Southern Oregon University
Design and Construct Rooftop Solar PV Systems at the Art & Marion Ady Buildings
RFP 2025-28
May 2, 2025

Addendum #1

Marion Ady MDP – Proposed Tie-in Location

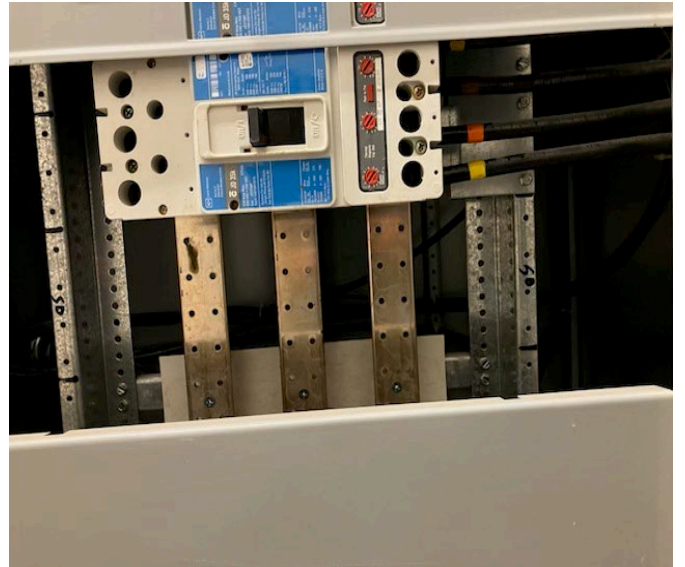
1. Grid Tie for the Marion Ady Building

A PV connection to the Main Distribution Panel in lieu of connecting the system to Subpanel S2A (as shown in the RFP documents) is approved.

2. Marion Ady MDP photos

Photos of the proposed PV grid tie-in location at the Marion Ady Building MDP are attached to this addendum
